Special Bryant Planning Commission Meeting

Date: March 24, 2025 - **Time:** 6:00 PM

1. Hawkins Valley Phase 1 - Preliminary Plat

GNE response to comments drawn in red

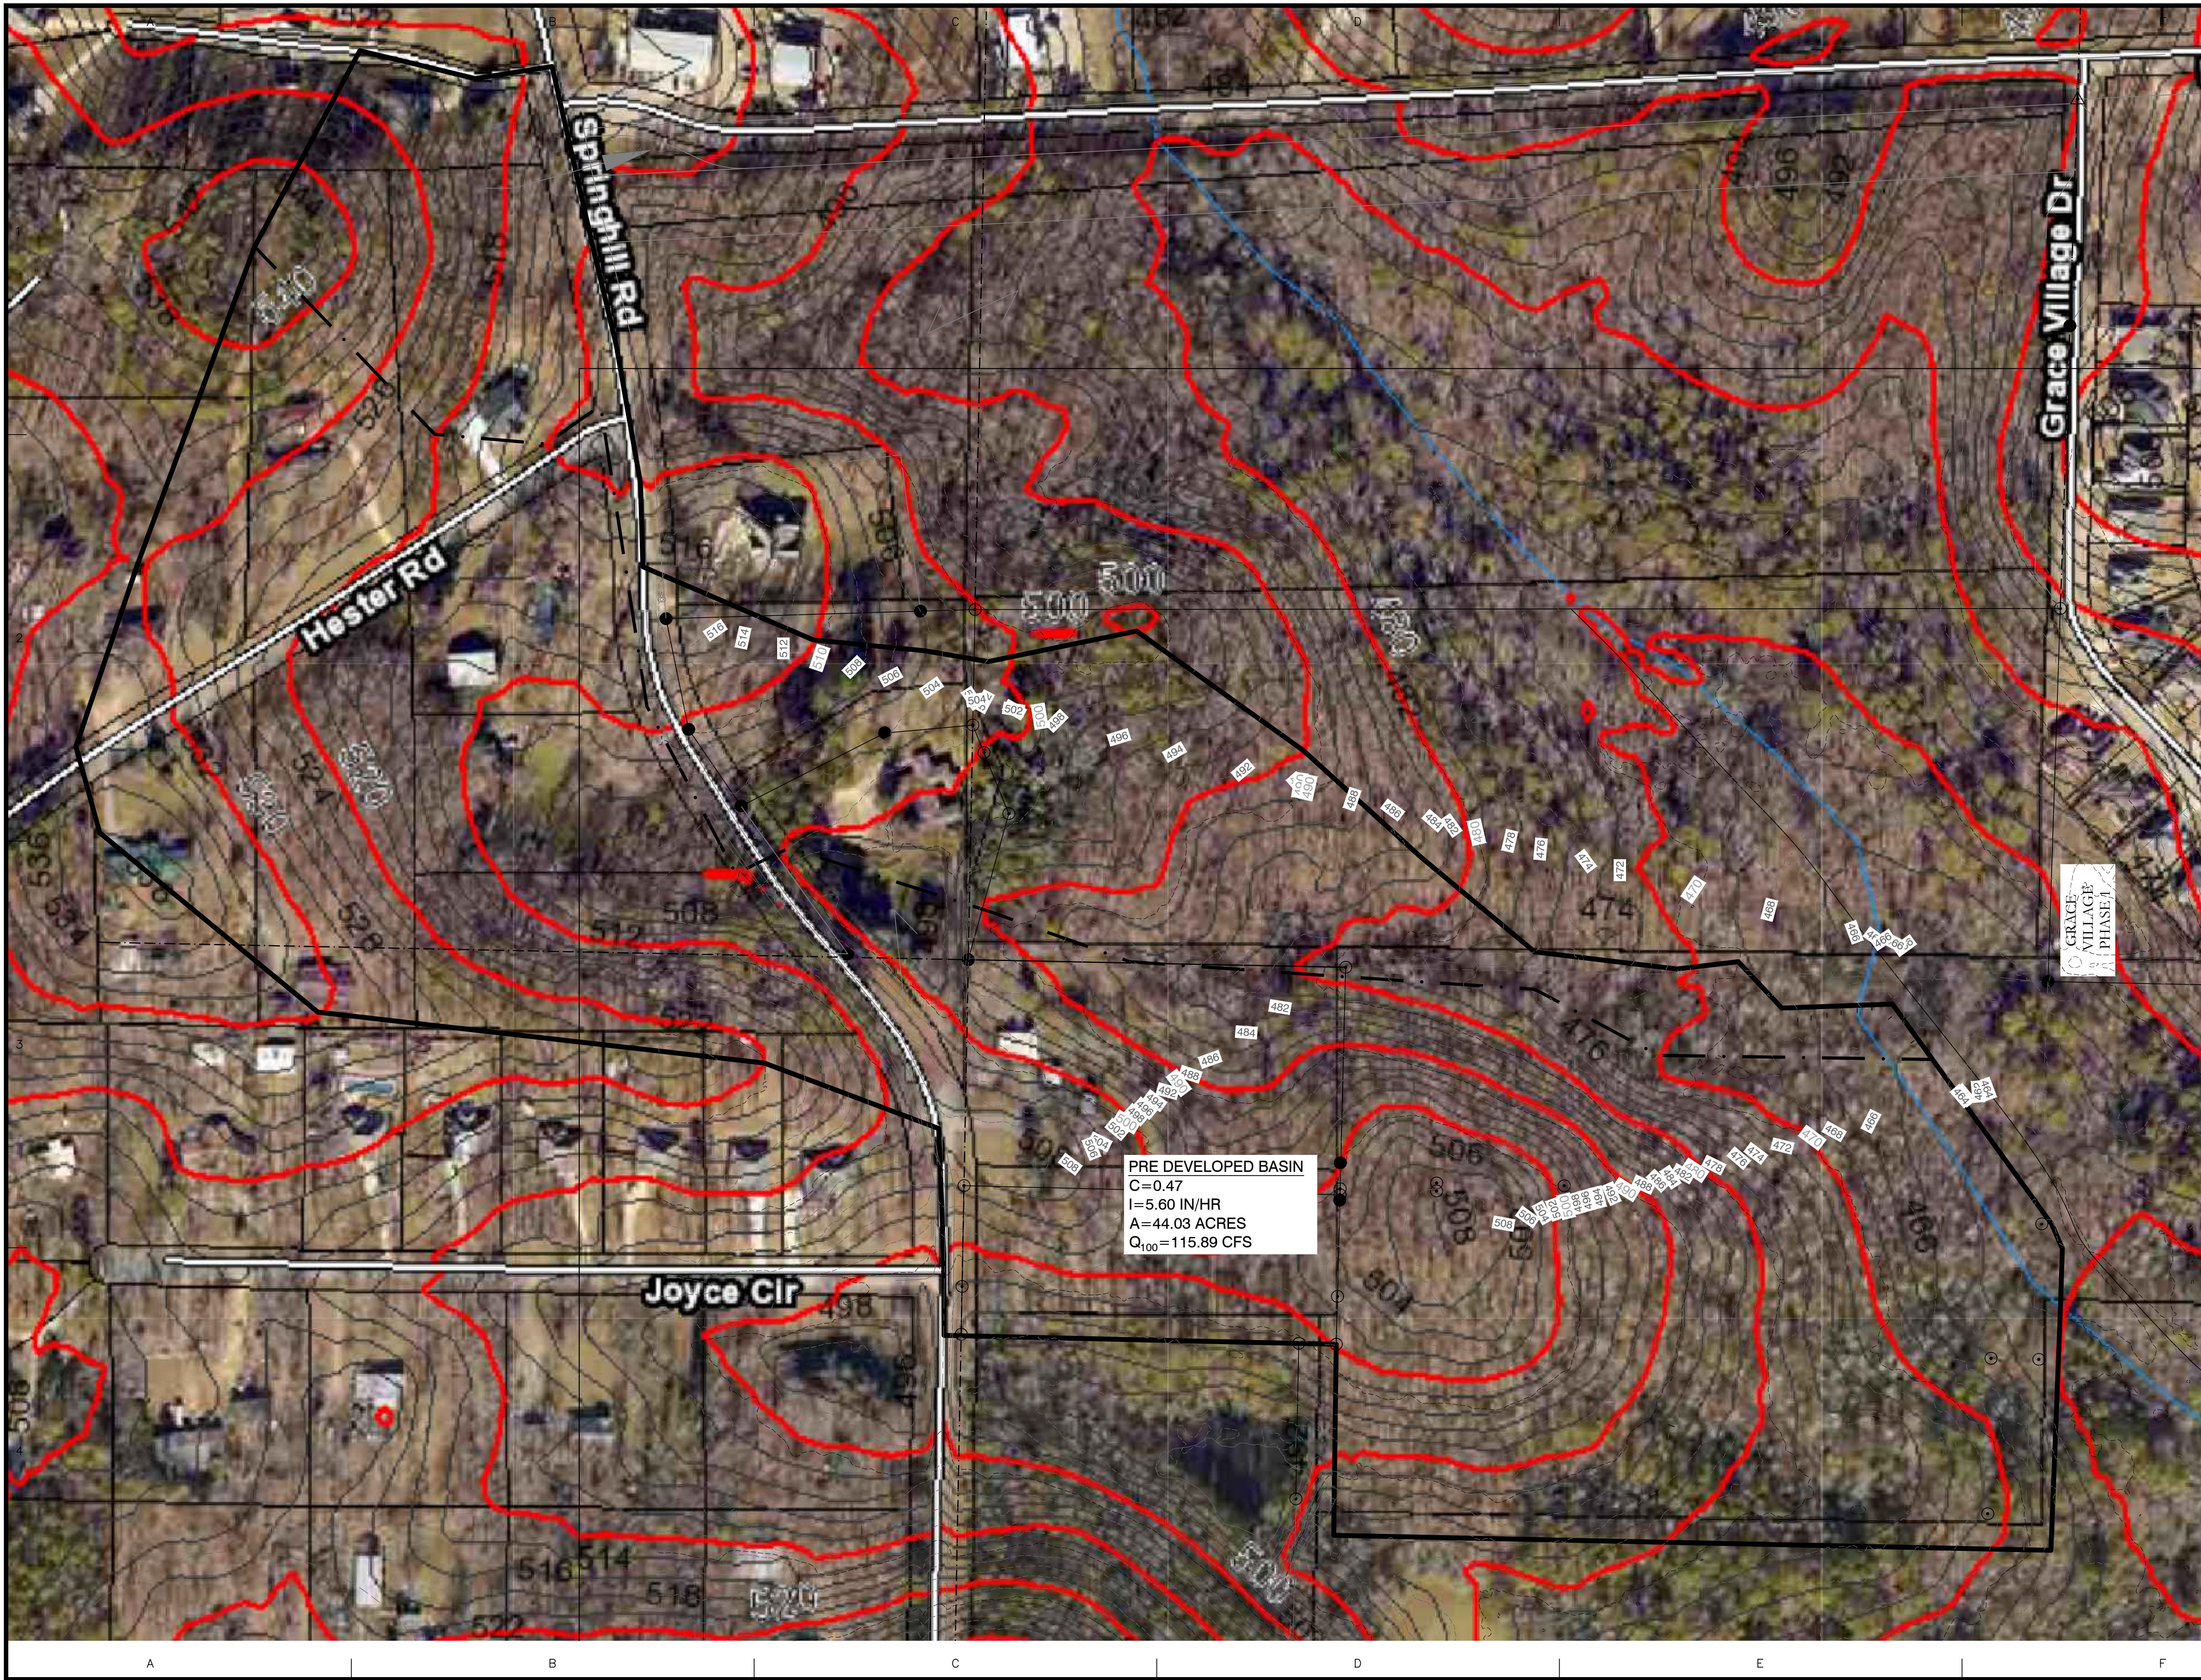
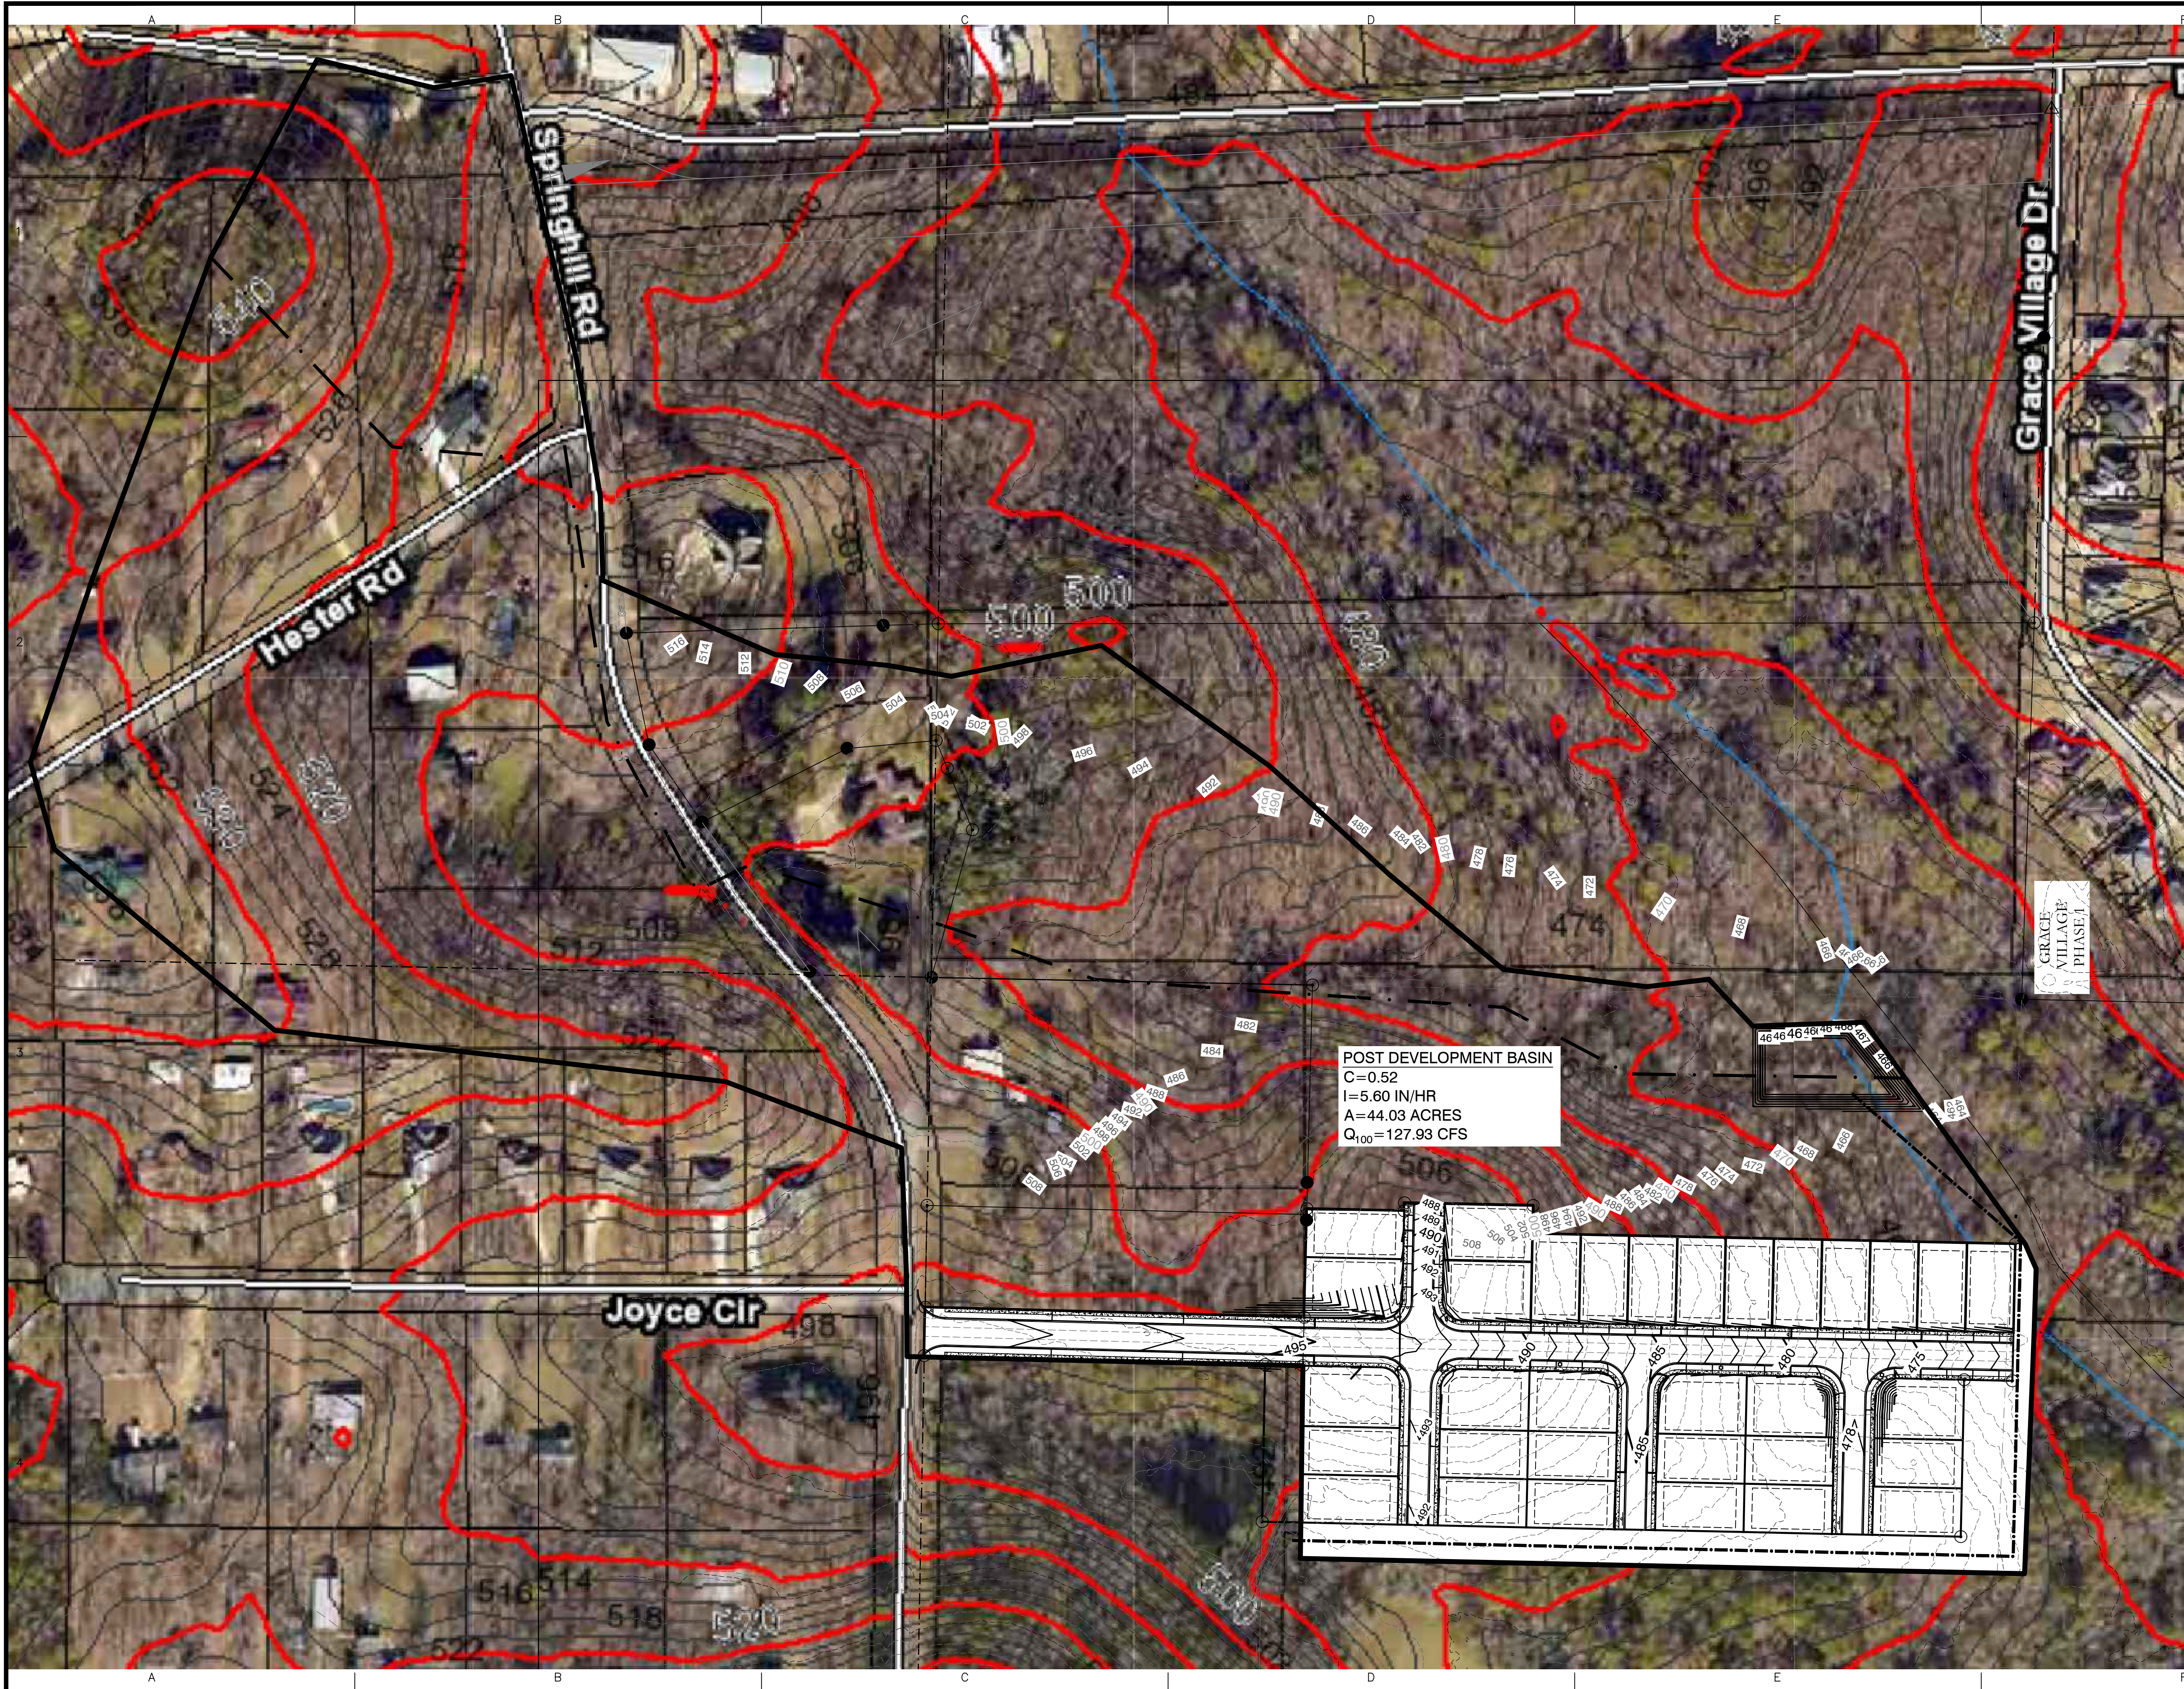
1. Page 3 – justification for roughness coefficients REFERENCE ADDED.
2. Page 4 – duplicate? NO, IT IS FOR POST DEVELOPMENT. IT WAS DESIGNED PER POST DEVELOPMENT FLOW. SEE PAGE 24 & 25

3. Page 9 – what basins is this based upon – see smaller basins / comments on page 22
4. Pages 11 & 12 – verify drainage basins SEE BELOW***
5. Page 13 – see comments on plan sheet PIPE SLOPES, SIZES, DITCH DETAILS, AND WEIR DETAILS ADDED. SEE PAGE 26 & 27.

6. Page 21 – Show enclosed storm pipe calculations for inside proposed phase PIPE SIZE CALCULATED BASED ON INLET BASIN.
7. Page 21 – Show ditch sizing calculations based upon actual contributing basins DITCH IS SIZED PER CONTRIBUTING BASIN.

8. Page 22 – see other basins not included in the calculations.
 - a. Show pond details and layout including control structure POND DETAILS AND WEIR DETAILS ADDED SEE PAGE 26 & 27.

- b. Show pipe sizes, slopes etc PIPE SLOPES, SIZES ADDED. SEE PAGE 26
 - c. Label ditch, show details,, slope, lengths, DITCH DETAILS, SLOPE AND LENGHT ADDED AND LABELLED. SEE PAGE 26 & 27.

9. Page 33 - Somewhere show a summary of the results of the pond and weir calculations ADDED PAGE 2.
10. Page 39 – Show details on pond POND DIMENSION, DEPTH AND WEIR DETAILS ADDED. SEE PAGE 26 & 27.

*** WE AGREE WITH THE BASINS. HOWEVER, WE DIDN'T CHANGE THE BASIN TO MEET THE BRYANT DEADLINE. WE WOULD LIKE TO ADD OUR PROJECT TO THE FEBRUARY AGENDA. ALL FLOWS ARE RELEASED TO THE CREEK TO COMPLY WITH THE BRYANT DRAINAGE CODE.
